**STAFF REPORT FOR THE PLANNING COMMISSION MEETING OF DECEMBER 17, 2019**

**FILE NO:** LU-2019-0070

**AGENDA TITLE:** For Possible Action: For Possible Action: Discussion and possible action regarding a request for a Special Use Permit to expand an Automobile Service Station use and to use an alternative approach to meeting the Downtown Mixed-Use development standards on property zoned Downtown Mixed-Use (DTMU), located at 1112 North Carson Street, APN 001-178-06. (Hope Sullivan, hsullivan@carson.org)

JACKSONS 169 EXPANSION  
 SPECIAL USE PERMIT  
 SITE PLAN  
 CARSON CITY, NEVADA

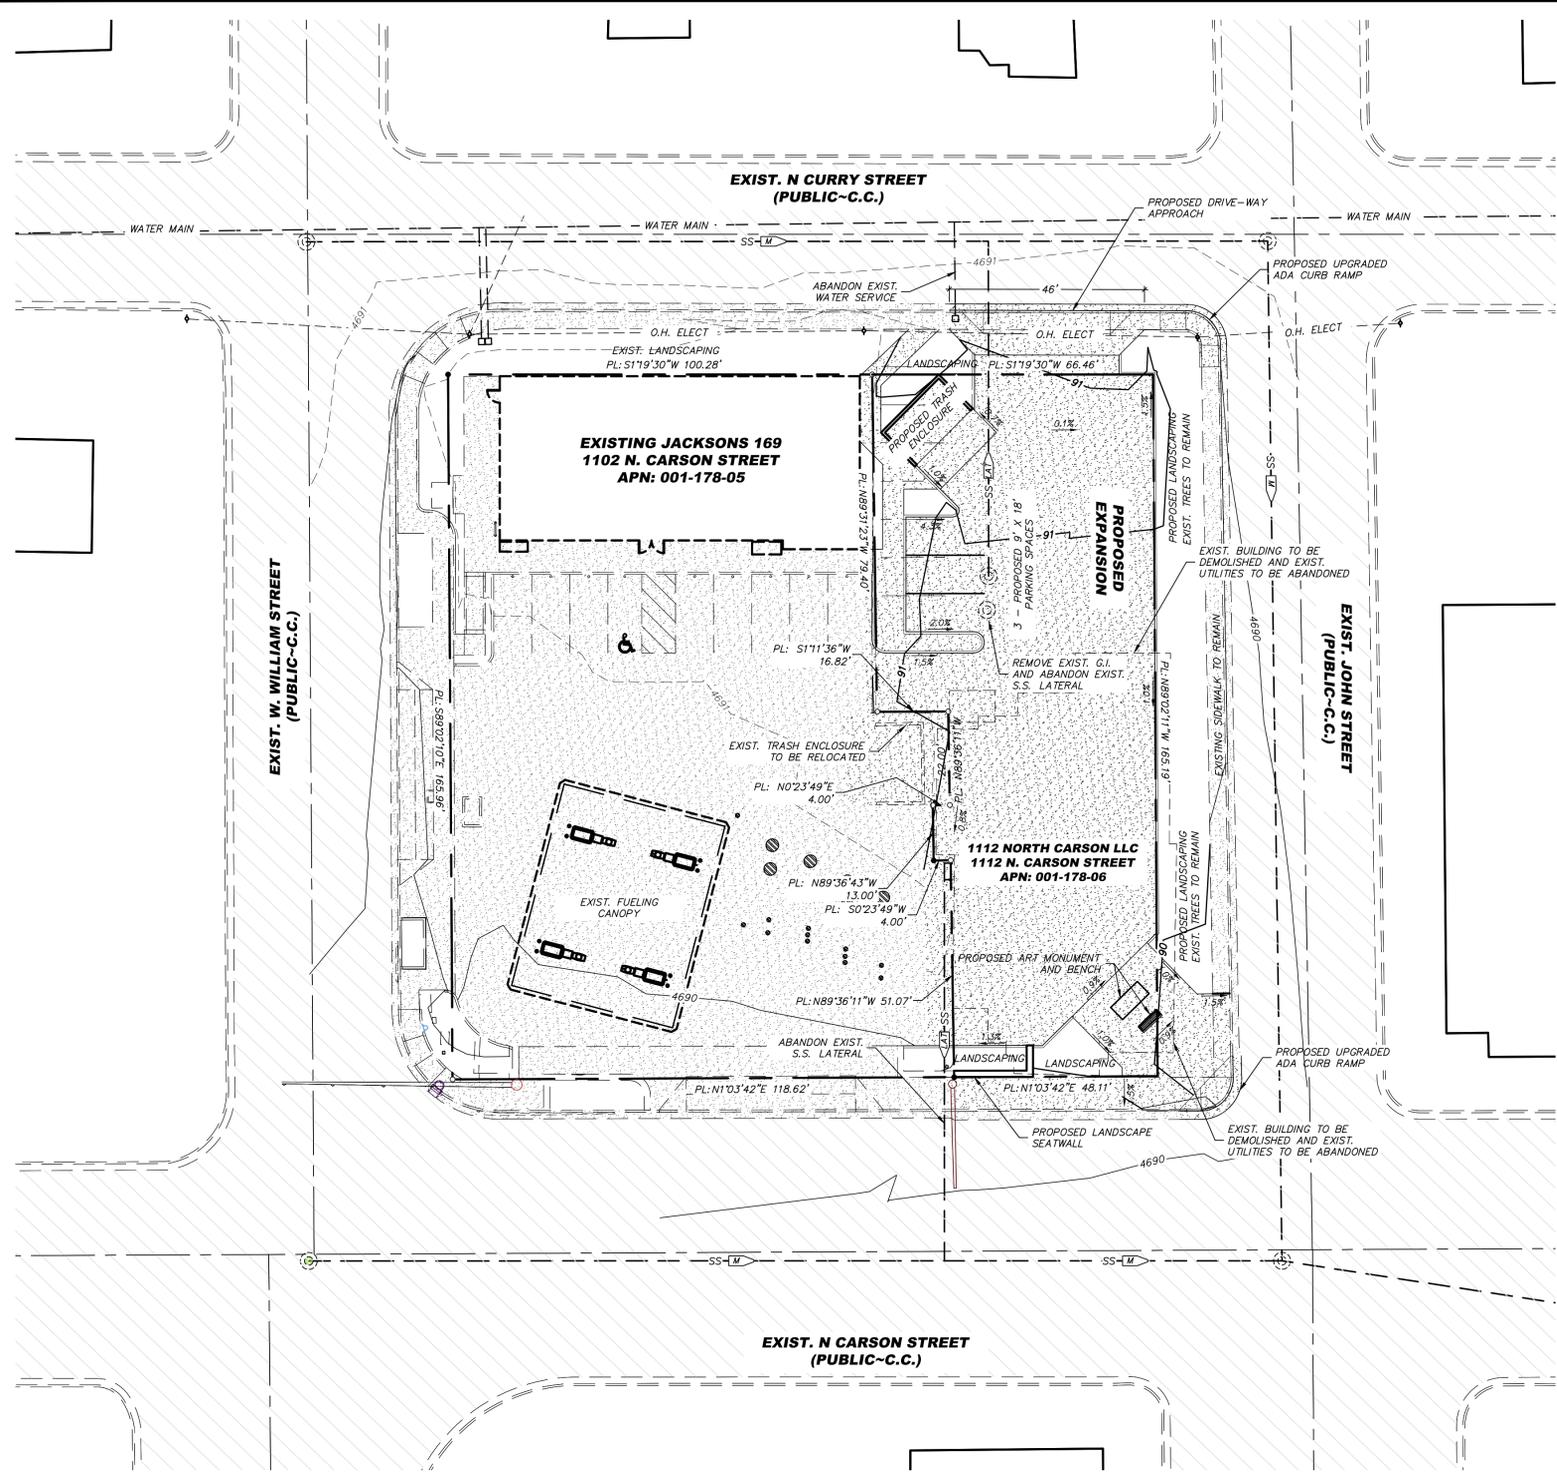
11. The driveway on Curry Street may not exceed the 34 foot maximum width for light commercial traffic.
12. Curb ramps at the northwest and northeast corners must be upgraded to meet current ADA standards as shown in the submitted plans.

13. Water and sewer laterals must be abandoned at the main as shown in the submitted plans.
14. The lots must be merged into a single parcel prior to issuance of the construction permit.

15. The exposed aggregate sidewalk along John Street must be removed and replaced with a sidewalk meeting City standards.

The plans call for an expanded driveway with a width of 46 feet on Curry Street. Per the City standards, the maximum driveway width for light commercial traffic is 34 feet. As the driveway opening will need to be reduced, staff recommends that the landscaping that currently exists behind the Jackson’s building be extended along Curry Street, where a six foot landscape strip is required.

Staff finds that the existing infrastructure and proposed drive isles are sufficient to provide safe access and circulation provided the curb ramps at the northwest and northeast corners are upgraded to meet ADA standards, the driveway width is reduced to 34 feet, and the sidewalk on John Street is repaired to meet City standards. The intention of the project is to improve on-site vehicular circulation.

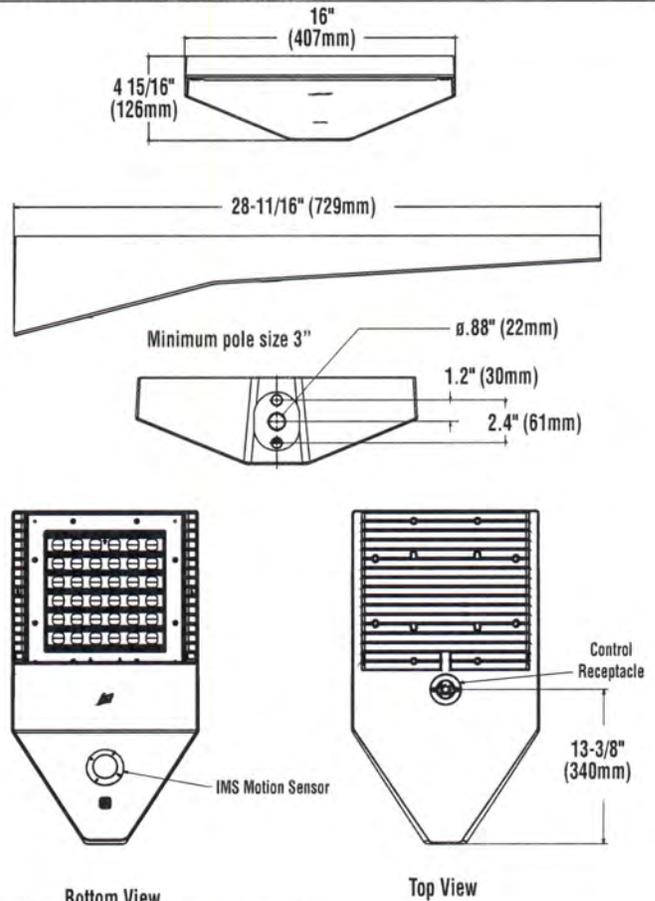
STAFF RESPONSE: The applicant proposes three lights along John Street. Staff finds the proposed lighting is not compatible with the established character of the downtown and the surrounding neighborhoods, and does not constitute the decorative lighting required in the

16. To improve the health of the trees on John Street intended for preservation, the ivy must be removed, and dead wood pruned.
17. The proposed light fixtures are not approved. Alternative lighting fixtures consistent with 6.6.2 of the Development Standards must be submitted for review and approval by the Community Development Director prior to installation.
